EAST PARK ESTATES
A PLANNED UNIT DEVELOPMENT

East Park Estates

SUB-Modification

CPC-ZC-PUD-SUB-ADJ19-08

TENTATIVE SITE PLAN PHASE 1 & 2

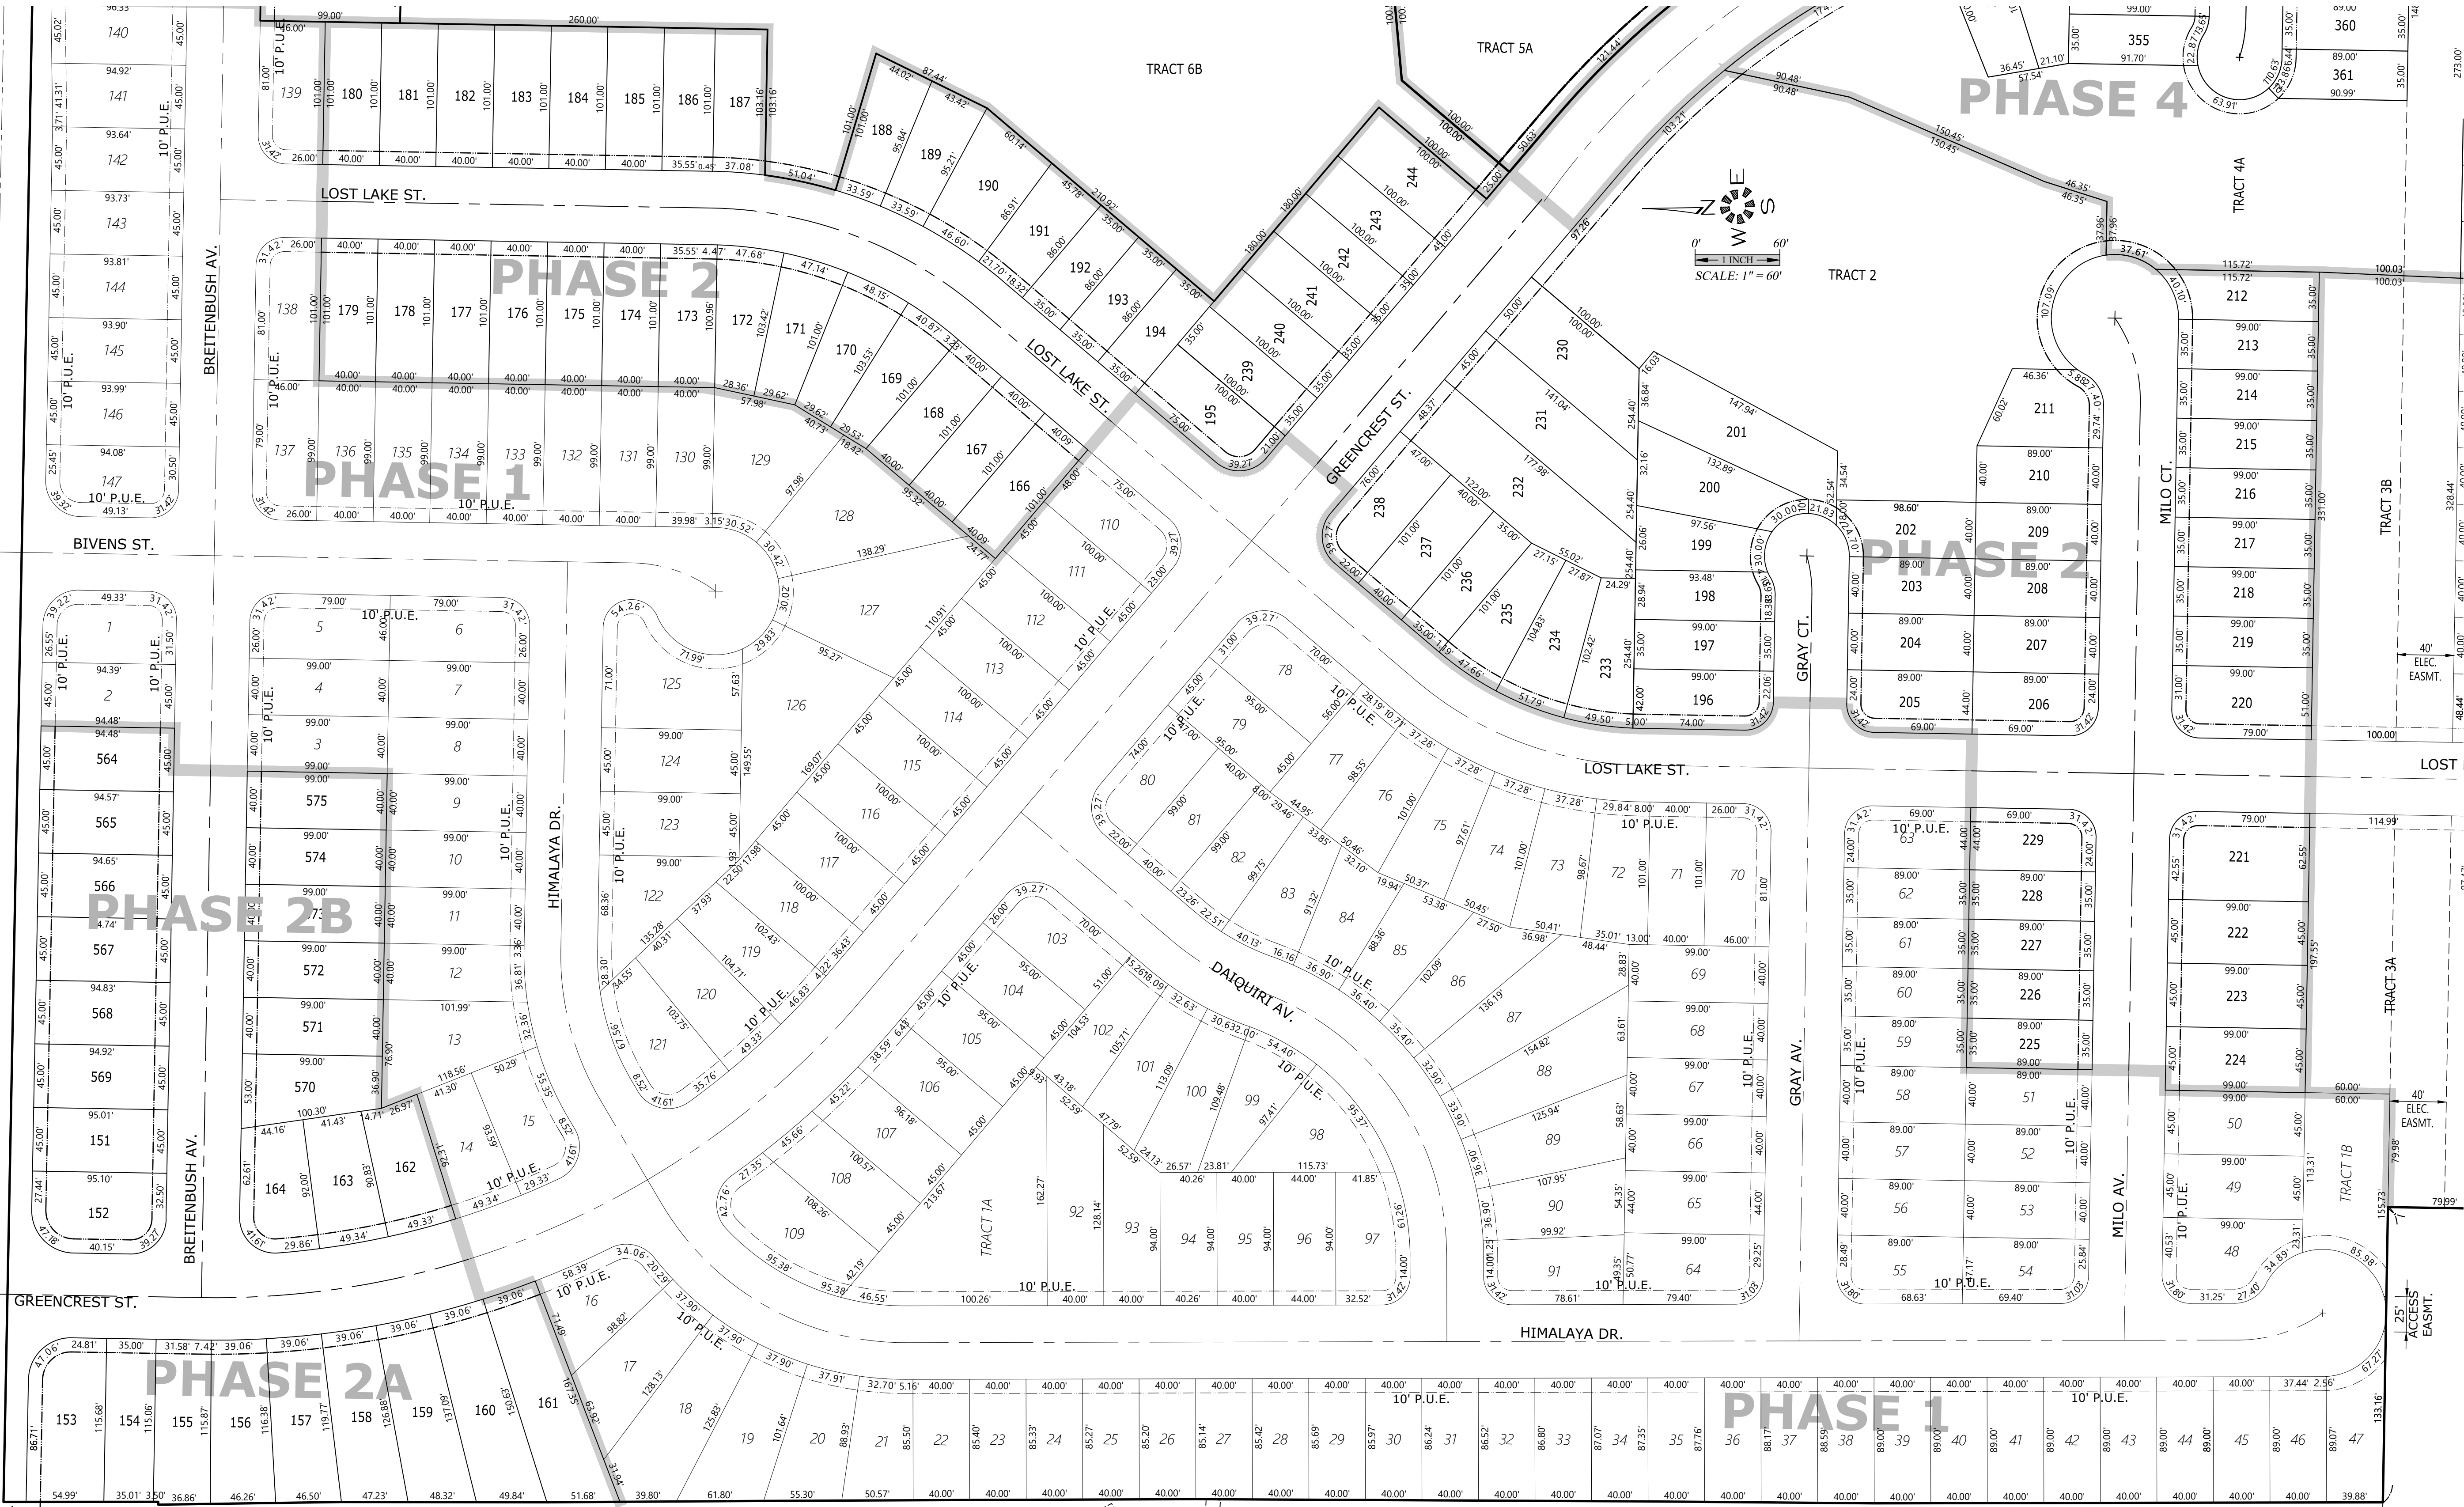
- 2) The applicant is also requesting a change in Phase lines as shown on the site plan, along with the addition of Phase 2B.
- 3) The applicant is also requesting an Adjustment to the Lot to Depth Ratio standard for Lots 153-155, 159, 160, 161, 231, and 232 in Phase 2 and Lots 468-472 in Phase 5.
- 4) The applicant is requesting to create the City Park and Commercial lots through Phase 3 of this modification.

Proposed Modification-April 2021

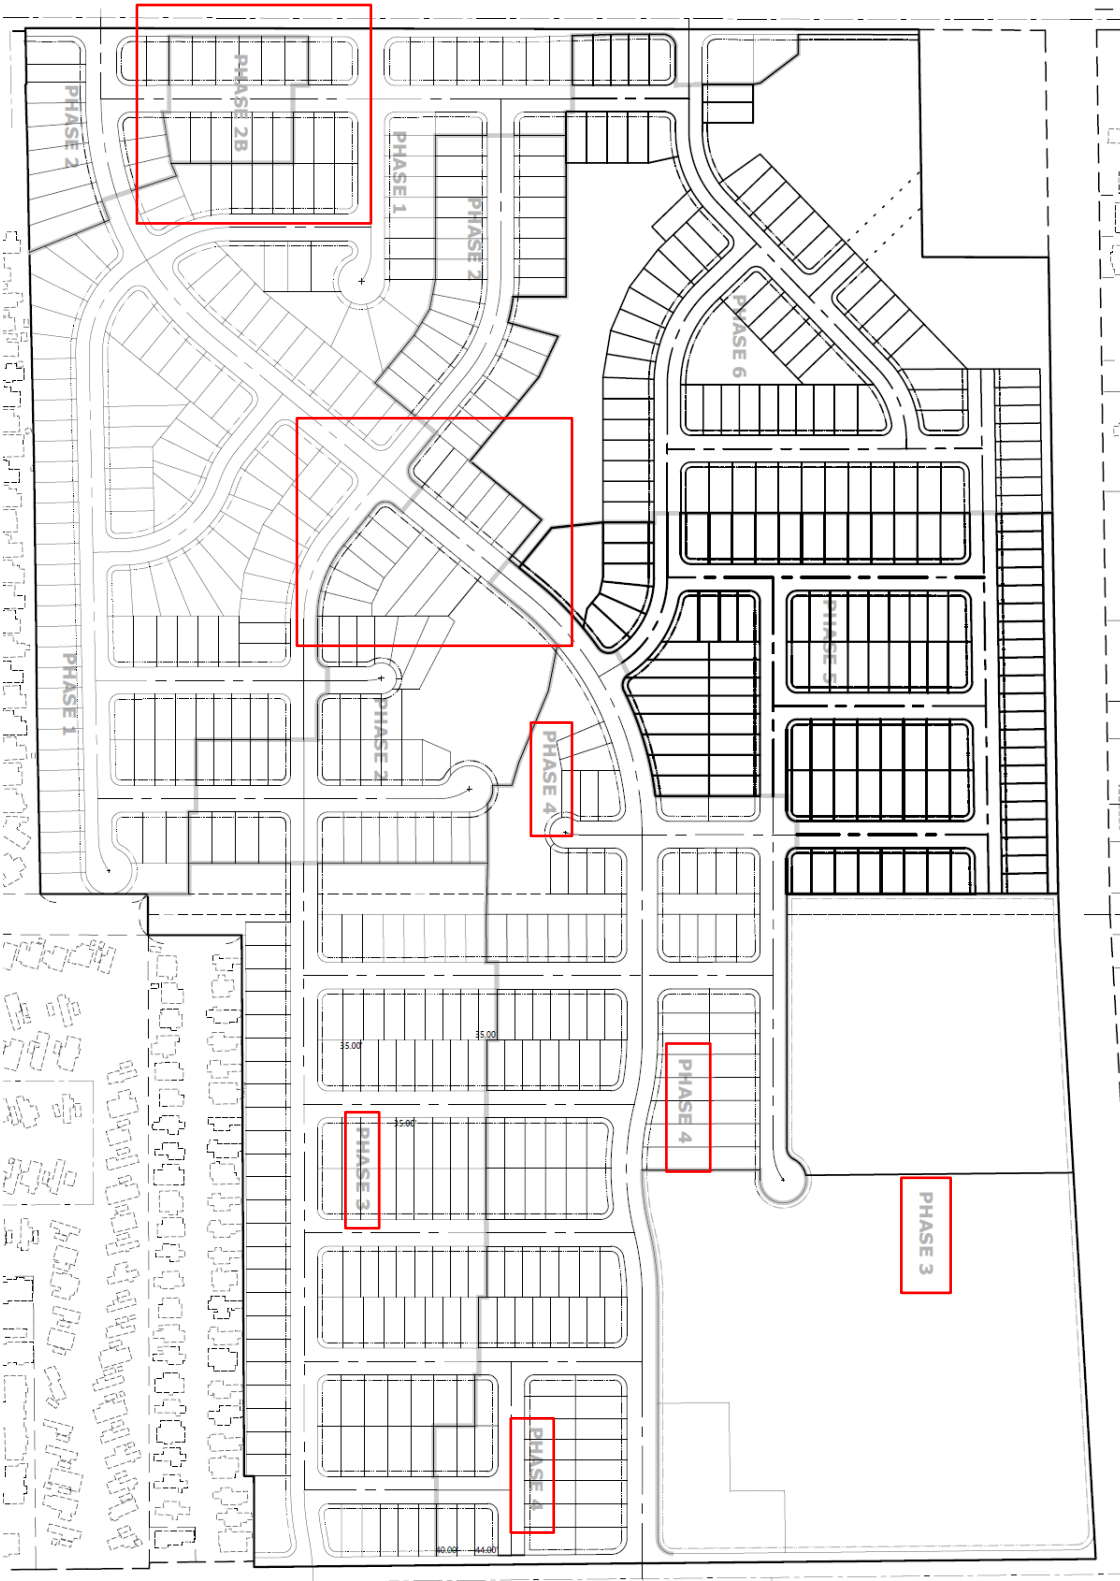
Attached is the proposed phasing plan. Phases 2A and 2B will be their own phases and we would like them to be able to plat at any point after Phase 2, we would also like the ability to plat them as a single phase if we choose to. We will dedicate the right of way and construct the section of Greencrest highlighted in red with the Phase 2 plat. With Phase 3, we will construct the dedicate the right of way and construct the section of Greencrest highlighted in green. We will construct Left turns on State Street at Lone Oak and at Greencrest with Phase 3. The remaining frontage improvements on State Street will be constructed with Phase 4.
